# Item 1: Shotover WWTP Long Term Disposal Solution Update

## Project: Shotover WWTP Long Term Disposal Solution

Purpose: Update on the Long Term Discharge Consent Application Post Lodgment

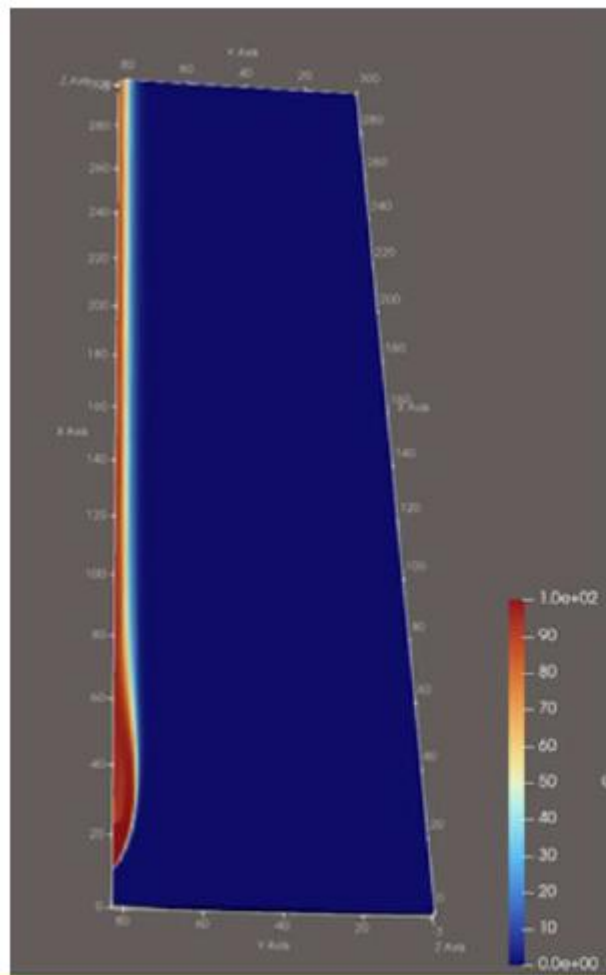
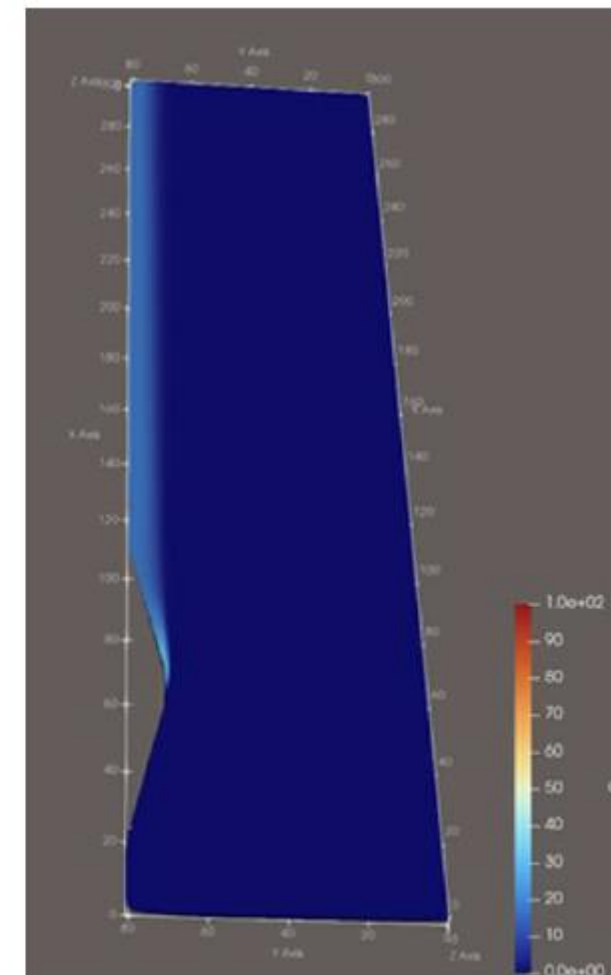
- **Conclusions:** predicted dispersion and mixing significantly improves when treated WW is discharged 10m out from the bank of the Kawarau River.
- **Diagram right shows predicted mixing with discharge via rock outfall structure.**
- **Diagram far right shows predicted mixing with discharge via piped discharge 10m into high flows.**

Figure 2 Predicted dispersions of effluent when discharged at the river edge.

Figure 3 Predicted dispersions of effluent when discharged 10 m out from the bank.

# Proposed Outfall Design Amendments

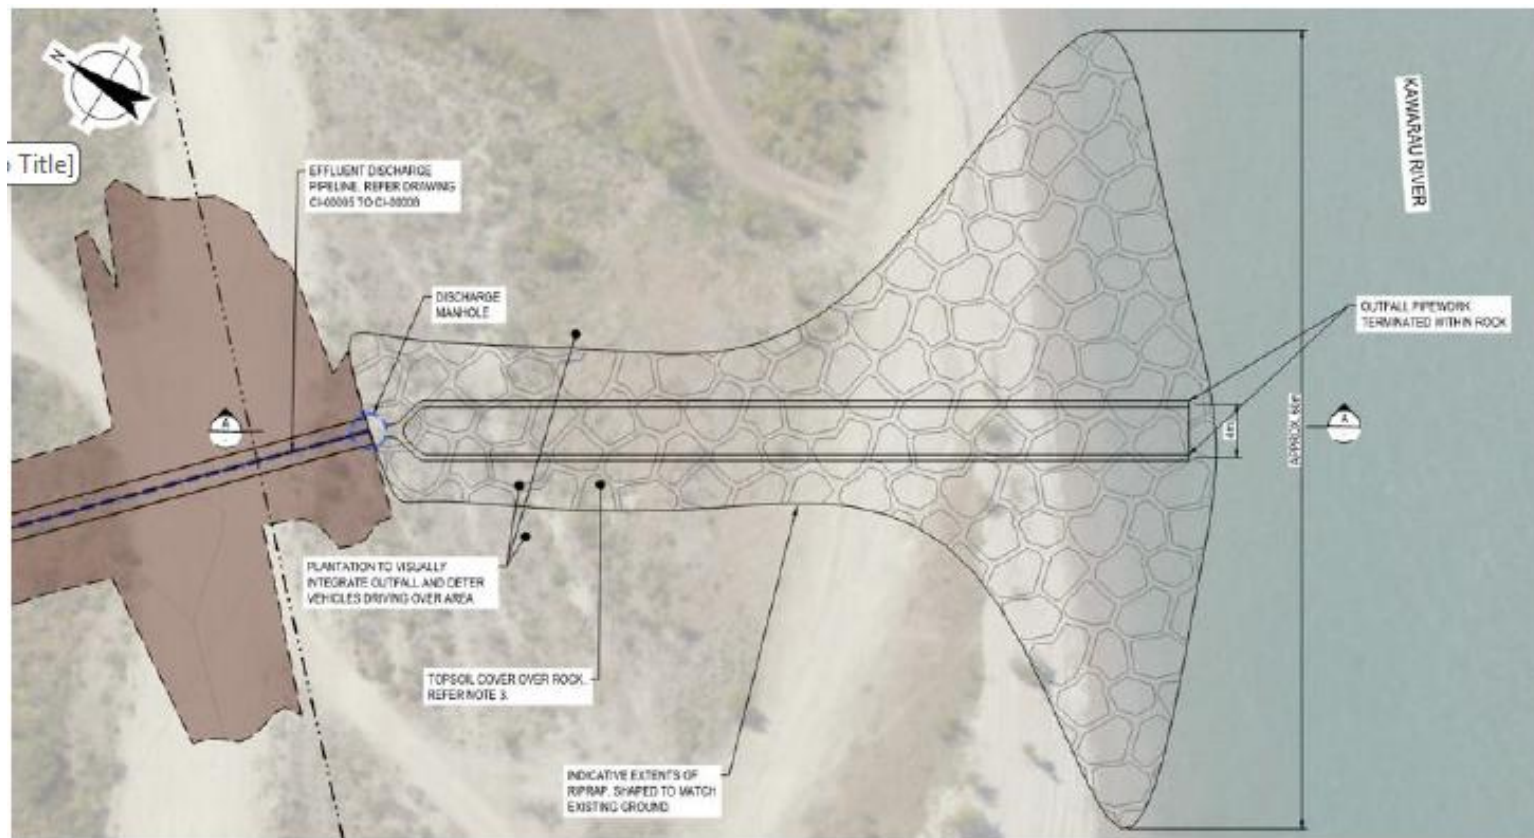
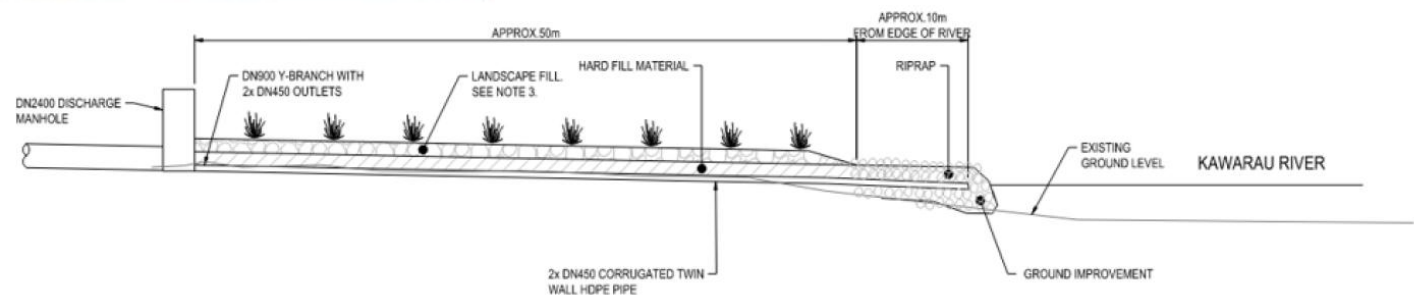
**Removal of the rock outfall structure and transition to a submerged pipe discharge** direct to more turbulent flows 10m + from the bank of the Kawarau River.

# Plant Upgrades – Proposed UV Disinfection System

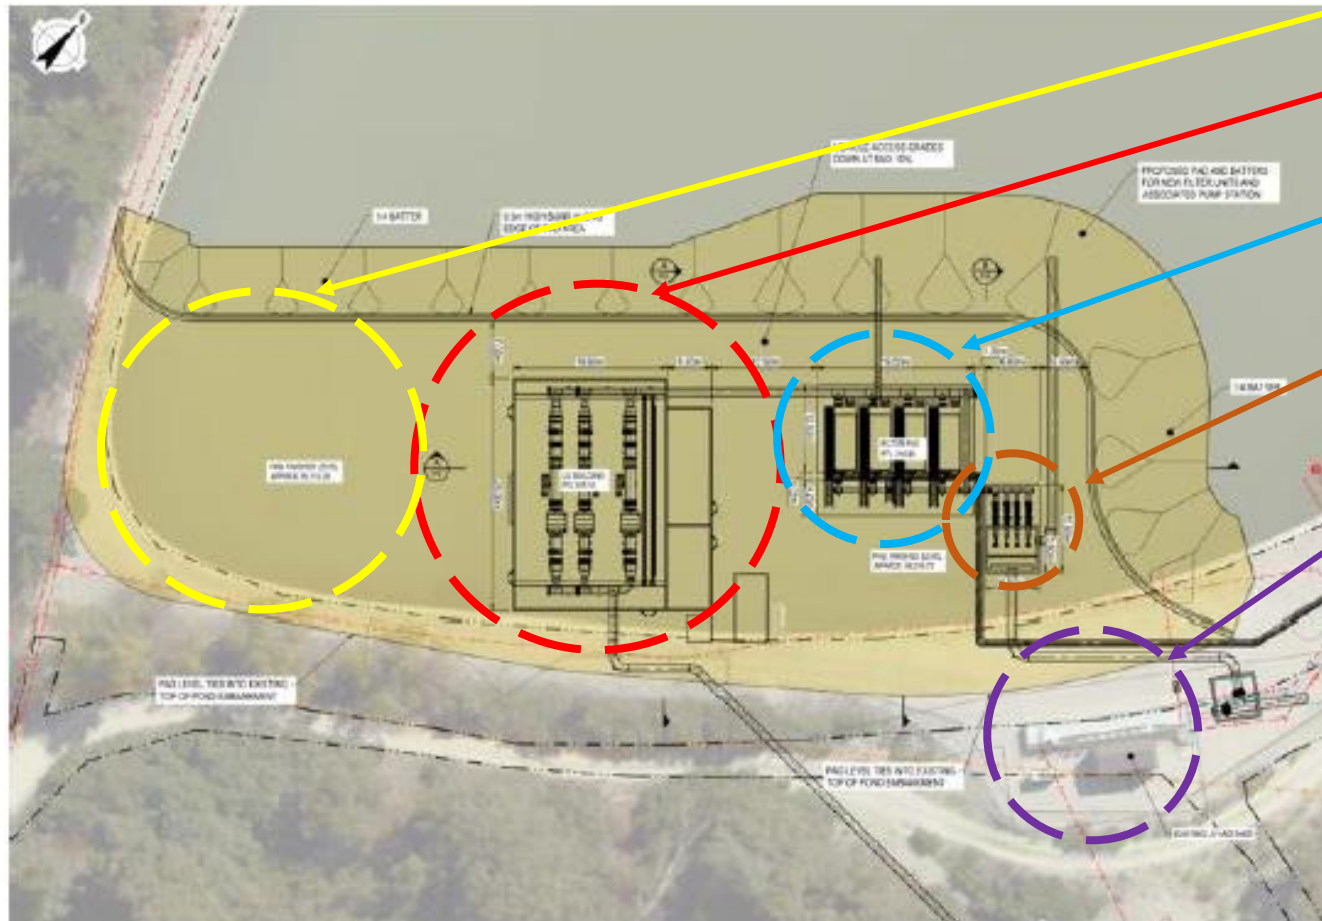
- **Proposed UV system:** Two UVFlex200 reactors each with 144 lamps (existing channel has 84 total) with provision in building for future reactor providing additional redundancy and expansion.

# Plant Upgrades – TP & DRP Performance

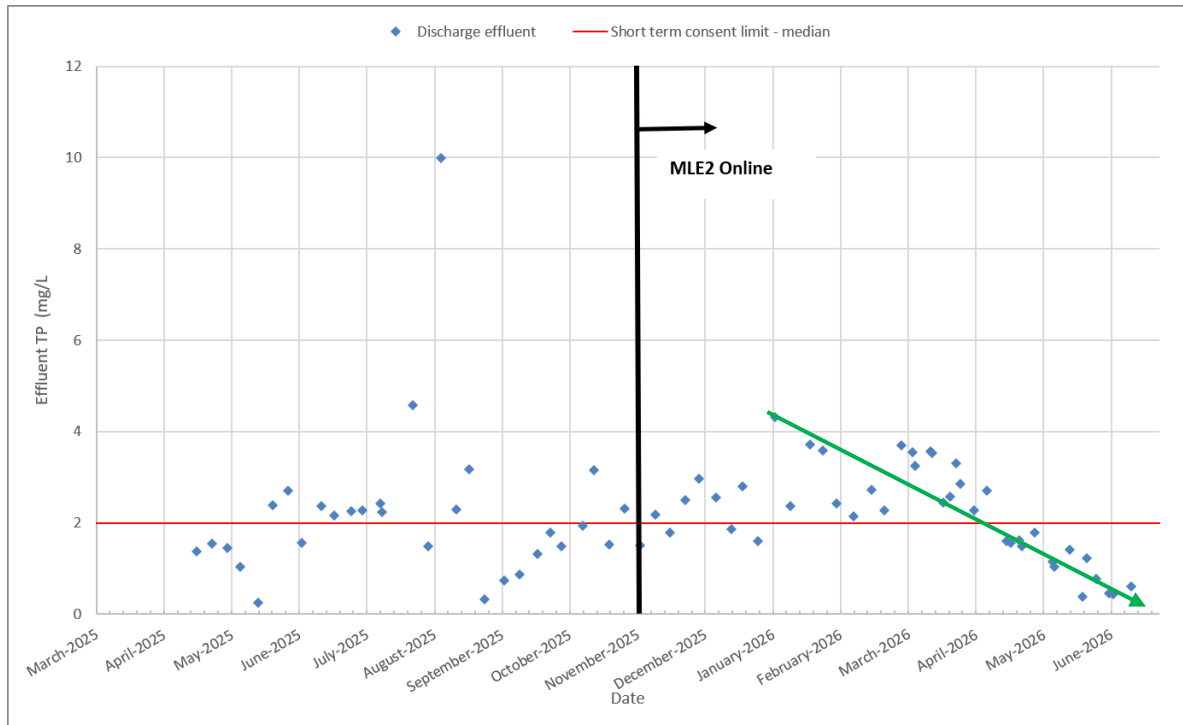
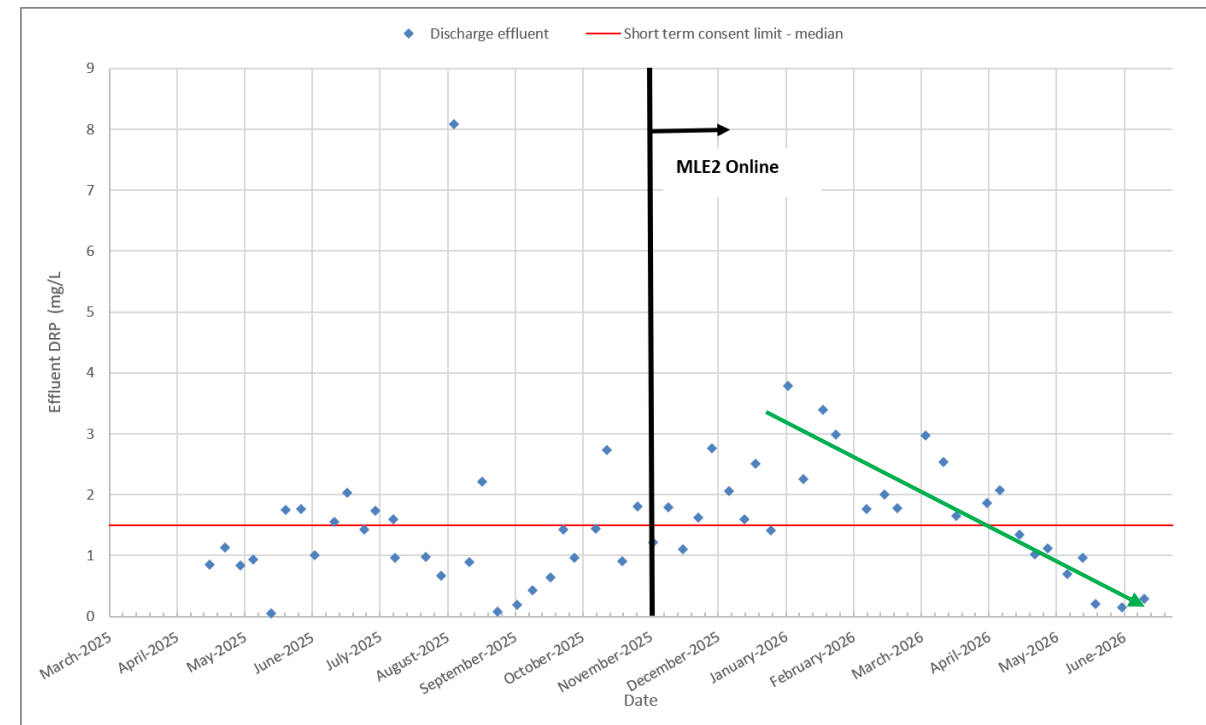
- Chemical dosing is required to reduce TP and DRP within the median limits, particularly when concentration is expected to increase again later in the year (suspected seasonal behaviour). Chemical dosing would then be a seasonal operation only.
